CITY COUNCIL SPECIAL MEETING MINUTES
JULY 11, 2022

CALL-UP BRIEFING: PLANNING COMMISSION APPROVAL OF A DESIGN REVIEW AND EXCEPTION TO STREET RIGHT OF WAY AND IMPROVEMENT REQUIREMENTS ("STREET EXCEPTION") APPLICATION PACKAGE FOR DO IT BEST AT 333 S. WOODLAND AVENUE (DR 22-01 & EXCP 22-03)

SUBJECT: **Annexation of Approximately 39.68 Acres of Territory Known as the Oregon Golf Association Property with no street address along the east side of Boones Ferry Rd NE north of Hazelnut Dr (ANX 22-02) and Approval of Related Land Use Applications for Development into the Marion Pointe Planned Unit Development (PUD)**

To: Planning Commission (June 23, 2022)

Exhibit PUD-3f: Site Plan Sheet P-26 Sidewalks (blue: min 8 ft wide); see Attachment 103 for full size

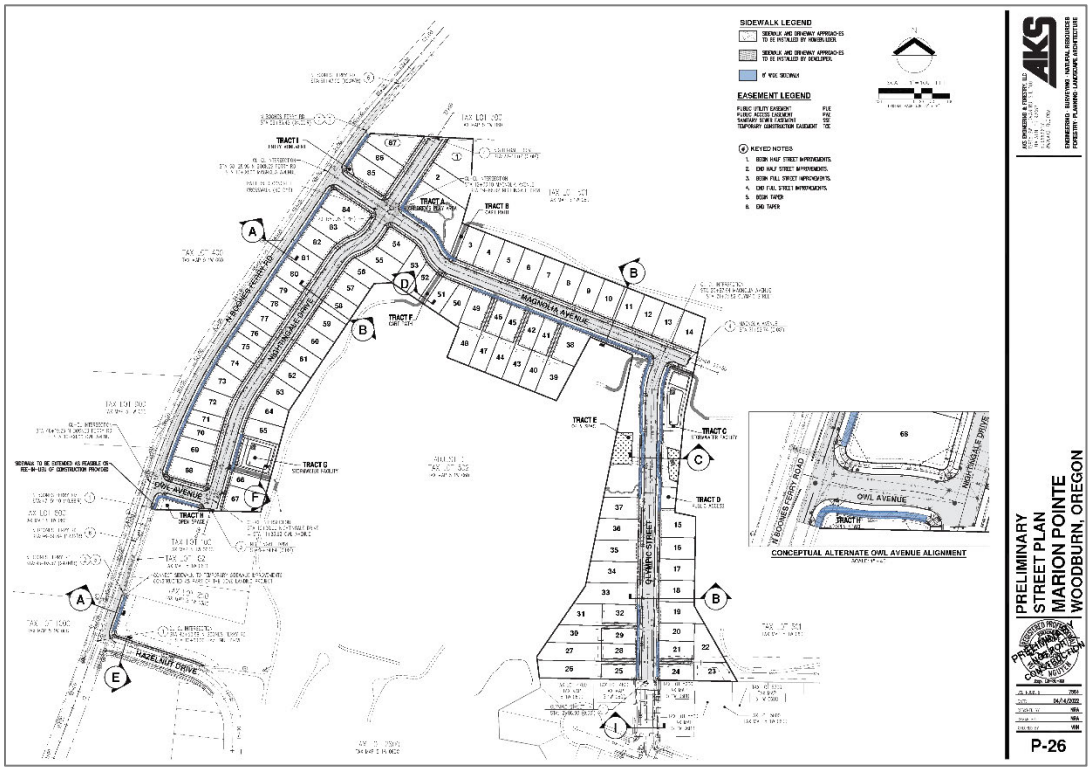
overlap, and taper to 6 ft through RPZs to save most of the loose row of trees along the road.

g. Overlap: The extra width of planter strip and sidewalk shall either (1) overlap outside ROW into streetside PUE and come with a recorded legal instrument granting public access to the overlap to the satisfaction of the Public Works Director, or (2) come with additional ROW to accommodate them. Wider sidewalks shall not narrow planter strips.

Exhibit PUD-3f: Site Plan Sheet P-26 Sidewalks (blue: min 8 ft wide); see Attachment 103 for full size

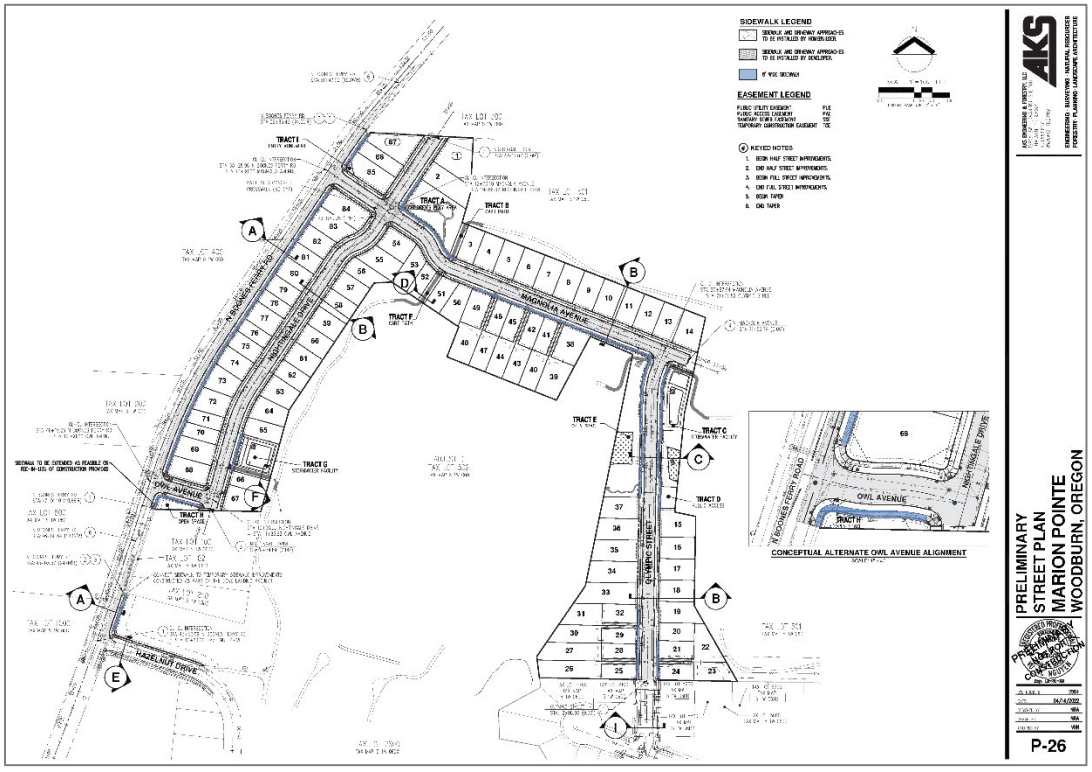
f. Sidewalks: Min 6 ft wide except wider as Exhibit PUD-3f supersedes. BFR sidewalk southerly and two northerly dead-ends shall have ADA-compliant transitions spanning between sidewalk and road shoulder as the applicable public works authority specifies. The segment extending north from Hazelnut sidewalk may meander, including PUE overlap, and taper to 6 ft through RPZs to save most of the loose row of trees along the road.

g. Overlap: The extra width of planter strip and sidewalk shall either (1) overlap outside ROW into streetside PUE and come with a recorded legal instrument granting public

Exhibit PUD-3f: Site Plan Sheet P-26 Sidewalks (blue: min 8 ft wide); see Attachment 103 for full size

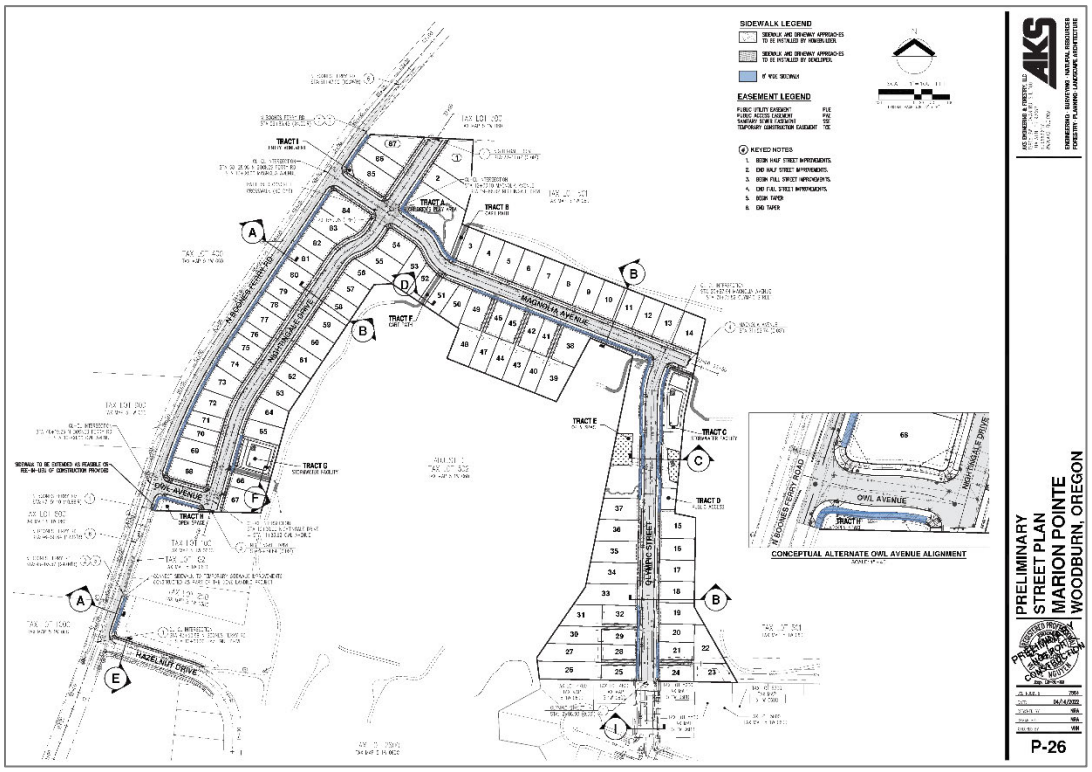
f. Sidewalks: Min 6 ft wide except wider as Exhibit PUD-3f supersedes. BFR sidewalk southerly and two northerly dead-ends shall have ADA-compliant transitions spanning between sidewalk and road shoulder as the applicable public works authority specifies. The segment extending north from Hazelnut sidewalk may meander, including PUE overlap, and taper to 6 ft through RPZs to save most of the loose row of trees along the road.

Exhibit PP1: Option 1 Site Plan Excerpt Prior to Revision per Conditions of Approval

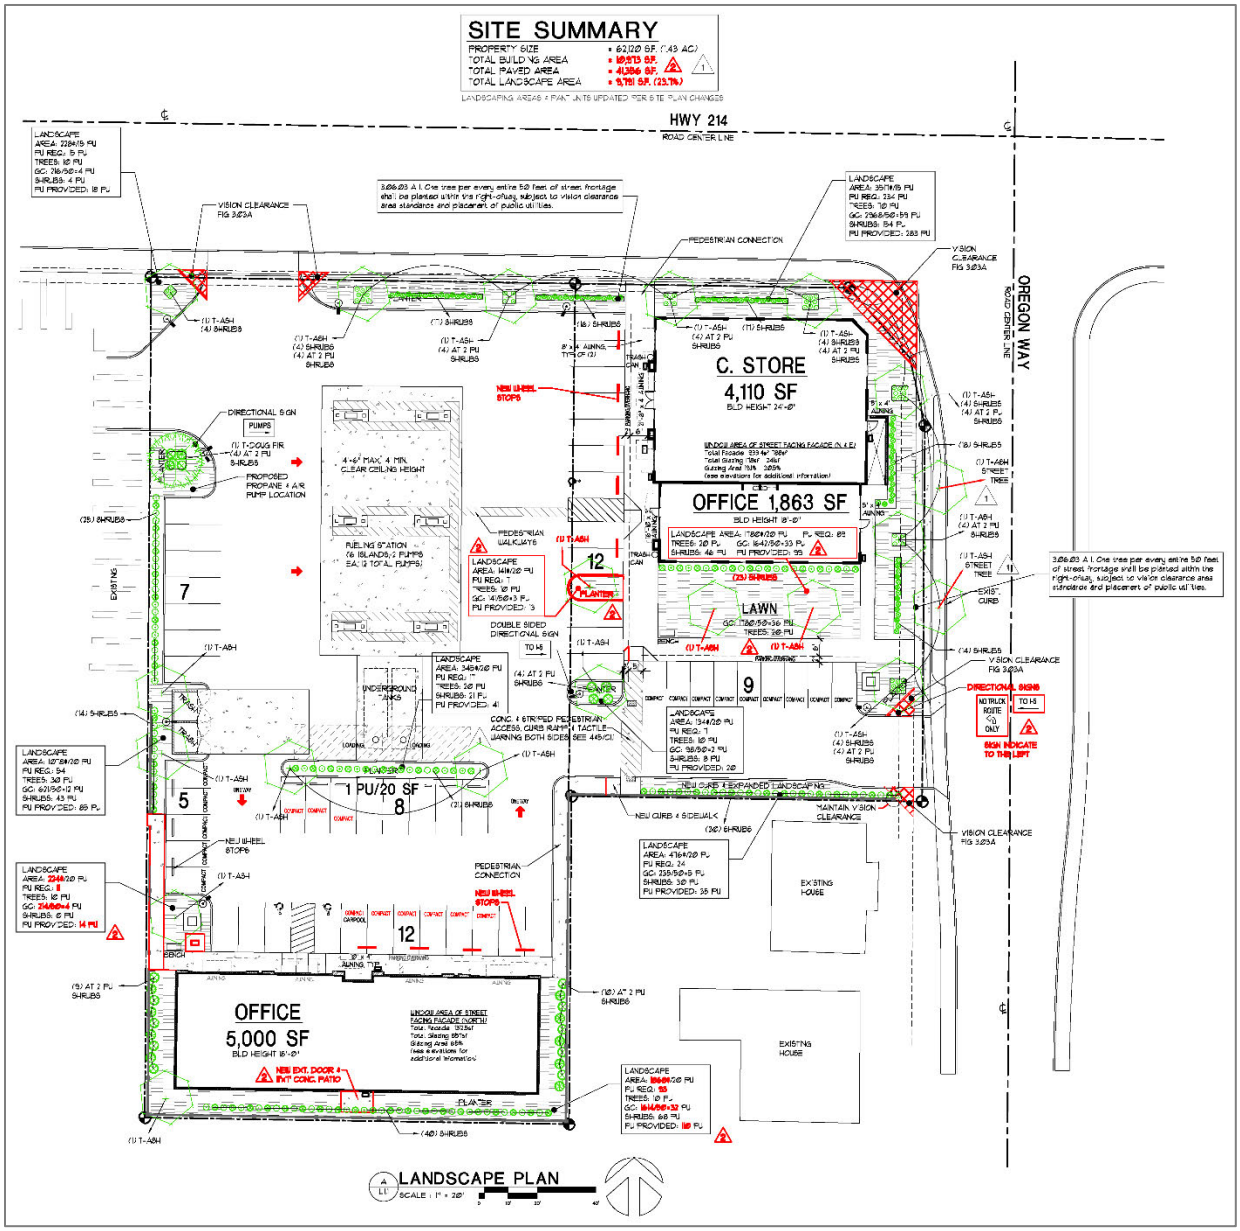
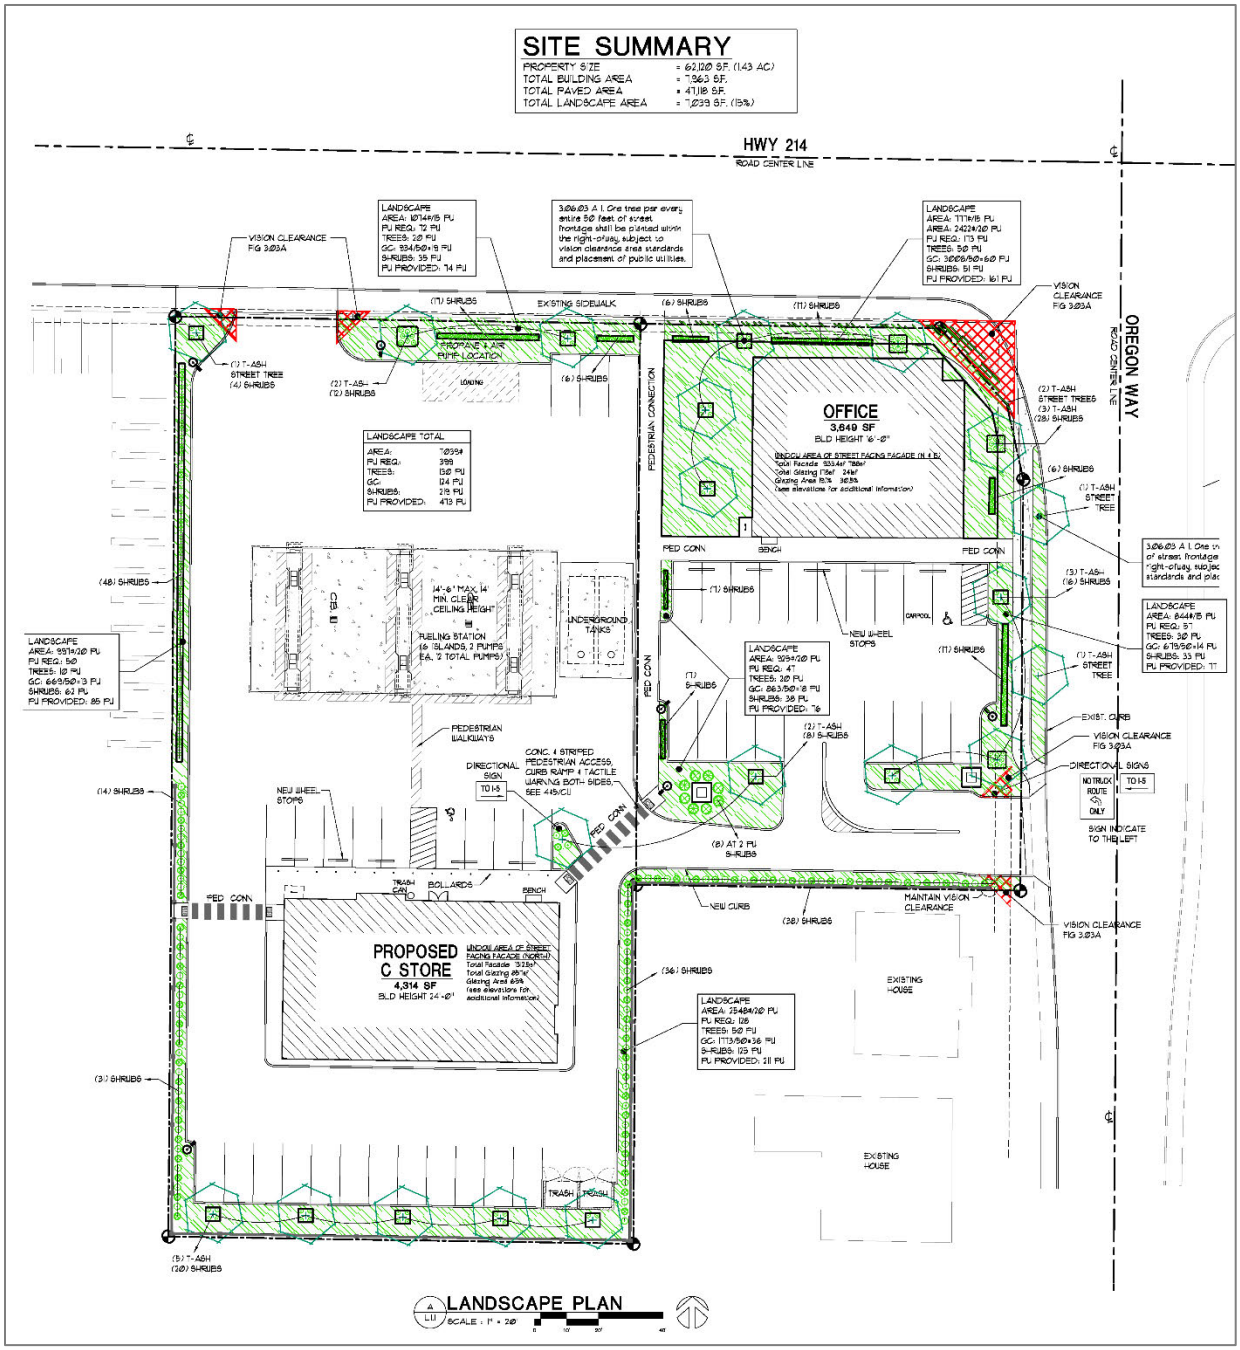
This due by building permit application.
2. Basic Descriptions:
   a. Option 1: See Exhibit PP1 below for plan details.
      (1) On Tax Lot 3600 (east, corner lot), a single northeast building of with convenience store of 4,110 sq ft and a commercial office of 1,863 sq ft.

(2) On Tax Lot 3700 (west, interior lot), a north fuel pump canopy and a south commercial office building of 5,000 sq ft.
   b. Option 2: See Exhibit PP2 below for plan details.

5. By and as part of building permit application, the applicant shall submit revised site plans meeting the conditions of approval.
6. **The Planning Commission prohibits Option 2 because of its decision at the June 9, 2022 hearing. Developer pursuit of Option 2 would require a Modification of Conditions (MOC) application and approval per WDO 4.02.07.**

Exhibit CU2d(1)

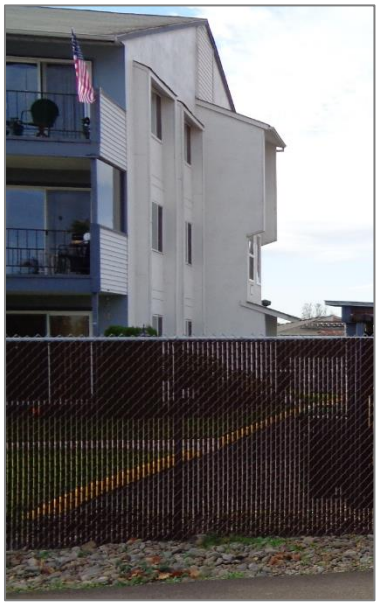
(1) There shall be one along the east lot line of Tax Lot 90000, min 4 ft wide and 6 ft, 8 inches high above grade, and with the south end of the gap aligned with the Tax Lot 90000 north east-west drive aisle, south curb, north face.

Exhibit CU2f (DR 2017-08)

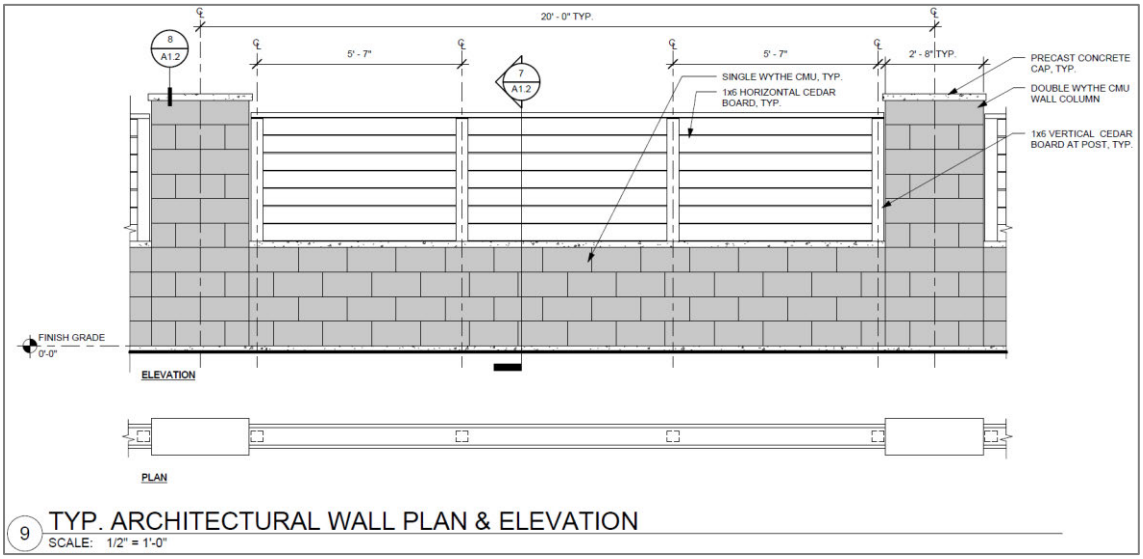
f. Material: AW segments ~~at 40 ft north or farther from the south lot line of Tax Lot 3700~~**, other than those along the north and east lot lines of Tax Lot 90000 (950 Evergreen Road),** may be partly made of opaque cedar wood fencing if the wall remains mostly masonry. Specifically, masonry must constitute the bottom extent of wall segment from grade up to min 2 ft, 8 inches above grade, and there shall be piers or pilasters per "Details" below. Exhibit CU2f below illustrates a similar, conforming example:

Exhibit PP1: Option 1 Site Plan Excerpt Prior to Revision per Conditions of Approval

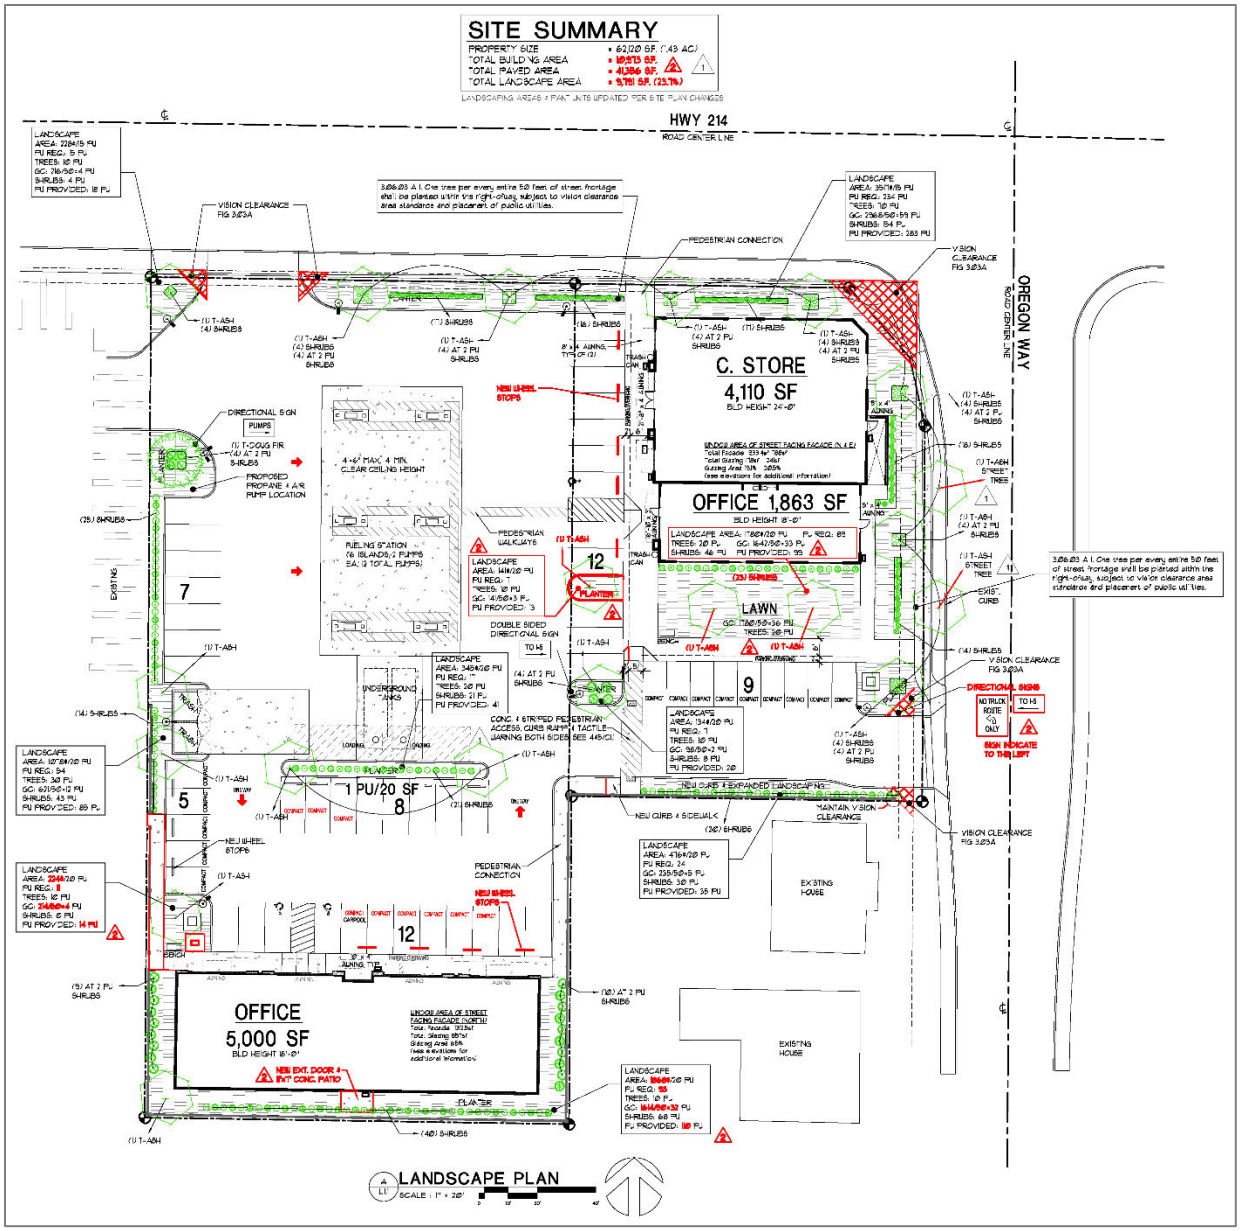
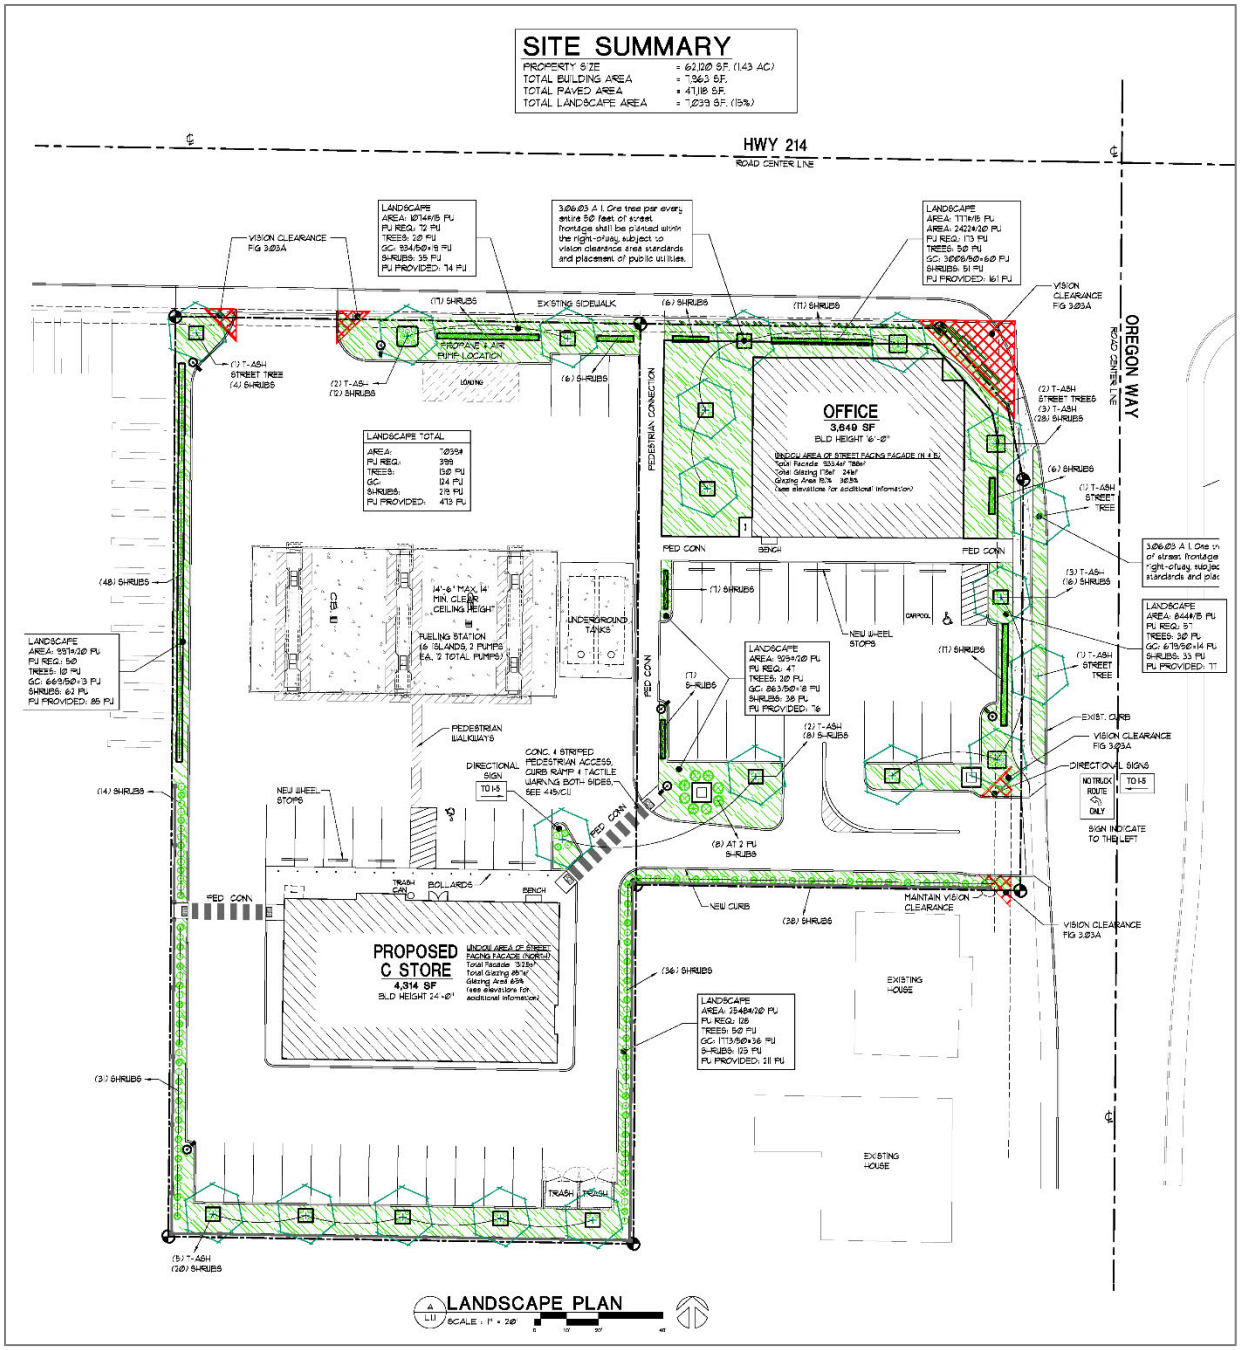
This due by building permit application.
2. Basic Descriptions:
   a. Option 1: See Exhibit PP1 below for plan details.
      (1) On Tax Lot 3600 (east, corner lot), a single northeast building of with convenience store of 4,110 sq ft and a commercial office of 1,863 sq ft.

(2) On Tax Lot 3700 (west, interior lot), a north fuel pump canopy and a south commercial office building of 5,000 sq ft.
   b. Option 2: See Exhibit PP2 below for plan details.

5. By and as part of building permit application, the applicant shall submit revised site plans meeting the conditions of approval.
